# Access Compliance Report

## Public Rights-of-Way

### (Curb Ramps)

Intersection ID: 10140	Main Street: E_36TH_ST	Cross Street: N_ALEXANDER_ST	Location: N
ADA ID: F2E0A88D6B5B	Ramp Type: PerpDiag	Initial Pass/Fail: Pass	Overall Compliance: No
		Severity Score: 0.25

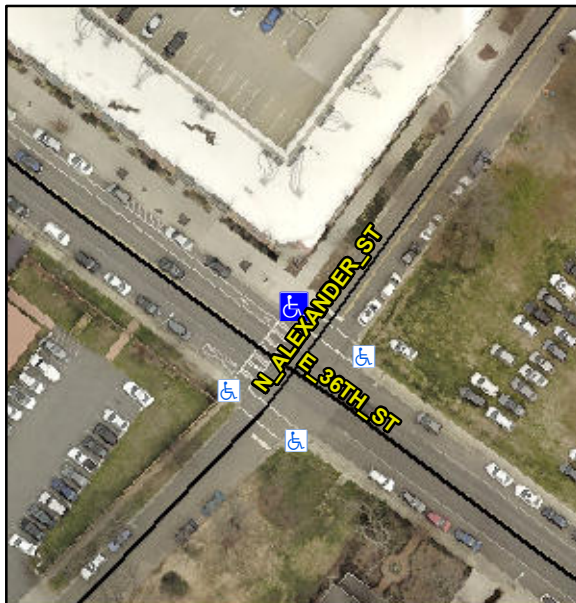
**Not Found, R304.5.3, R305.2**

Compliance	Description	Data	Compliance	Description	Data
N/A	Ramp Length (in)	96.0	Yes	Ramp Slope (%)	5.2
Yes	Ramp Width (in)	48.0	No	Ramp XSlope (%)	3.0
N/A	Flare Type LT	Sloped	N/A	Flare Type RT	N/A
N/A	Flare Slope LT (%)	9.5	Yes	Flare Slope RT (%)	1.2
N/A	Flare Traversable LT?	Yes	N/A	Flare Traversable RT?	Yes
Yes	Landing Length (in)	48.0	Yes	DWS Provided?	Yes
Yes	Landing Width (in)	48.0	Yes	DWS Contrast?	Yes
Yes	Landing Slope (%)	0.3	Yes	DWS Length (in)	24.0
Yes	Landing X Slope (%)	1.5	Yes	DWS Full Width?	Yes
N/A	Landing Curb? (Y/N)	No	No	DWS Offset (in)	5.0
N/A	Shared Landing?	No			
Yes	Gutter Ponding?	No	Yes	Gutter Slope (%)	2.2
Yes	Gutter Lip Ht (in)	0.0	No	Gutter X Slope (%)	5.5
N/A	Painted X Walk1?	Yes	N/A	Painted X Walk2?	Yes
	X Walk 1 Direction	To SW		X Walk 2 Direction	To SE
N/A	X Walk 1 Width (in)	110.0	N/A	X Walk 2 Width (in)	103.0
	X Walk 1 Slope (%)	4.0		X Walk 2 Slope (%)	4.0
	X Walk 1 X Slope (%)	1.6		X Walk 2 X Slope (%)	4.9

**Remove & Replace Curb Ramp With Two New Directional Ramps or Equivalent. Remove & Replace Gutter.**
